E. I. DU PONT DE NEMOURS & COMPANY

CENTRAL RESEARCH & DEVELOPMENT DEPARTMENT

January 27, 1982

NRC LICENSE NO.: 07-00455-37

GROUND FLOOR

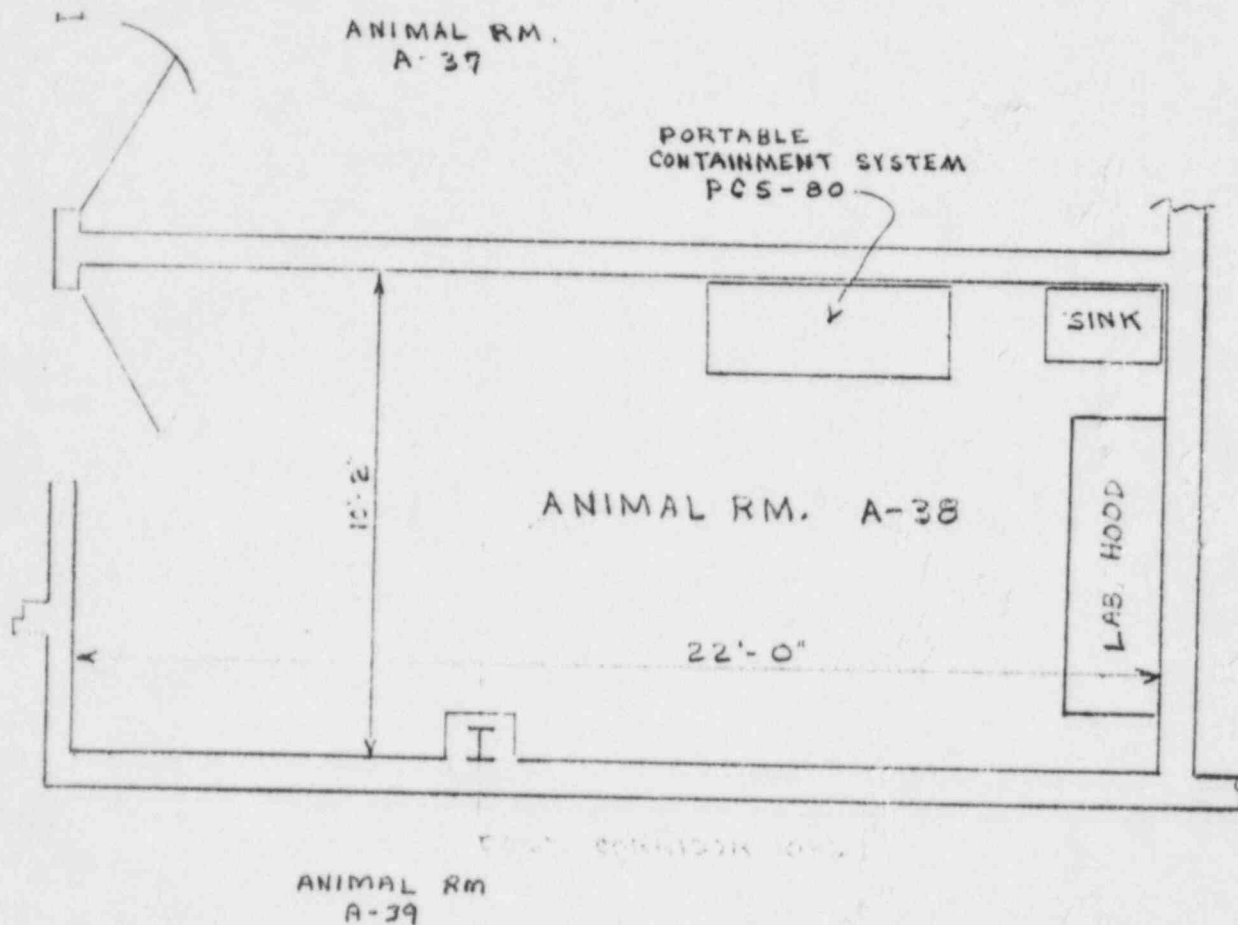
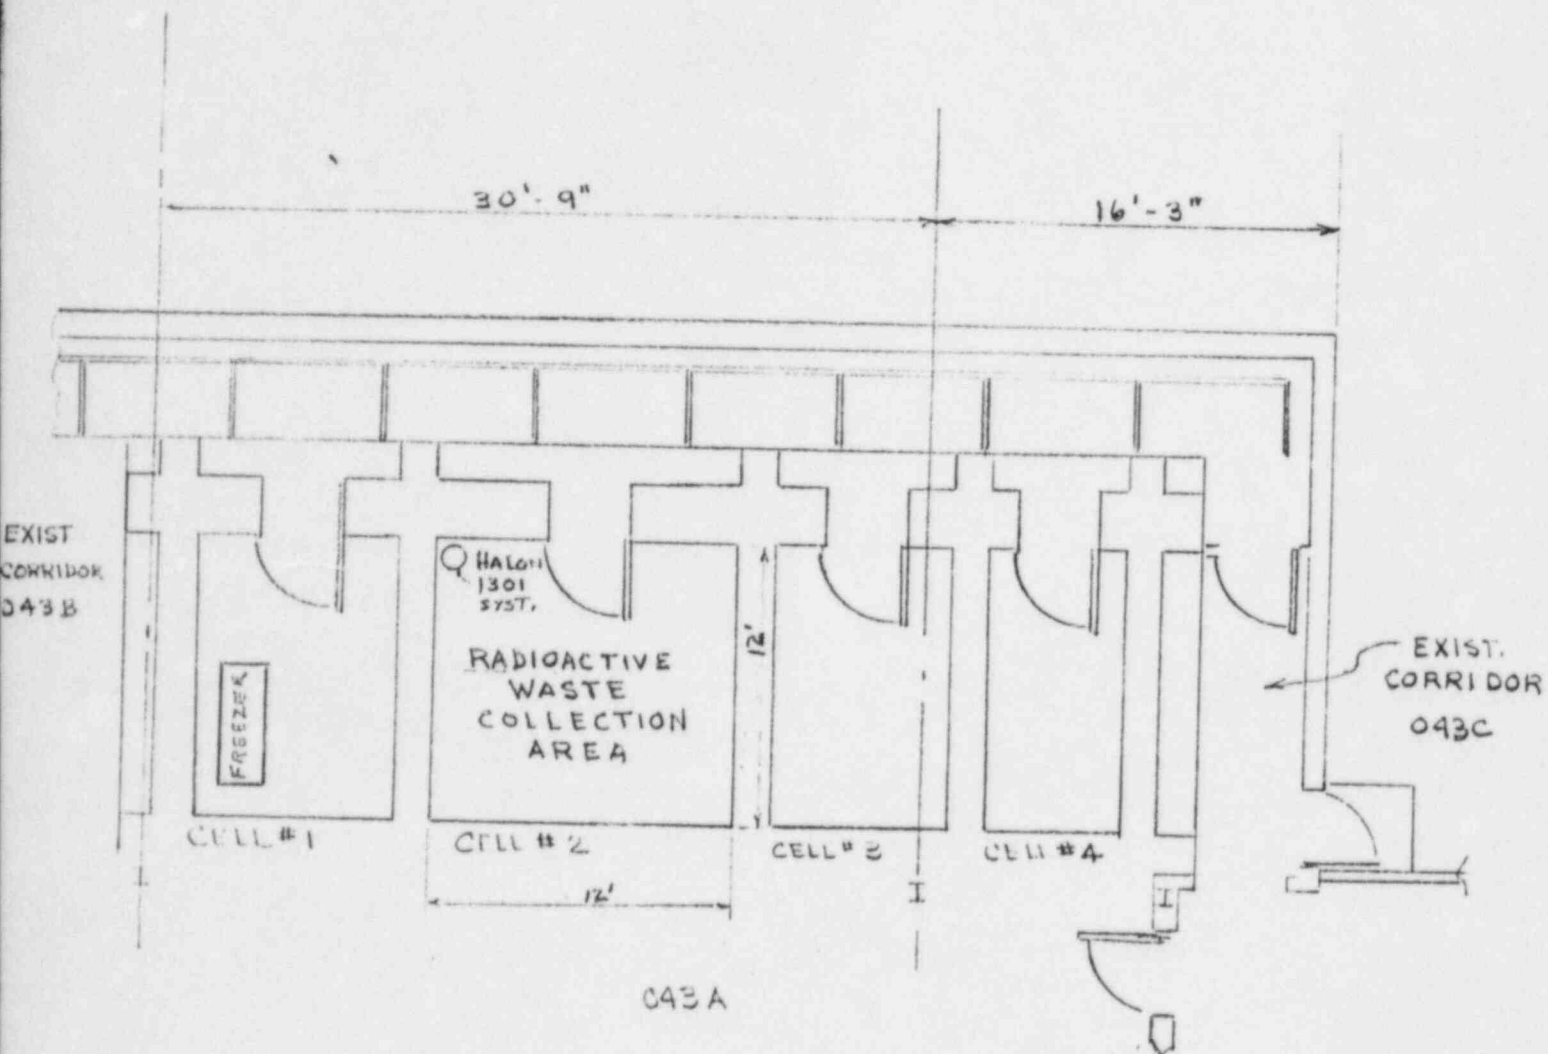
The animal laboratory housing the Hazelton PCS-80 portable containment unit will be located in Room A38 instead of A39 as originally planned.

The Atomic Energy of Canada Gammacel-40 Irradiator will be located in Room 051 instead of Room 054 as originally planned. This unit is covered under separate license (No. 07-00455-36) and a separate letter requesting this change is being sent to the NRC Radioisotope Licensing Branch, Washington, D.C., which issued the license for the irradiator.

A locked freezer for storage of radioactive animal carcasses prior to packaging in Teledyne Isotopes, Inc. drums for shipment to an approved disposal site has been

installed in Cell No. 1 (adjoining Cell No. 2 listed on our license application as the radioactive waste storage area). Cell No. 1 may also be used for additional radioactive waste storage capacity if needed.
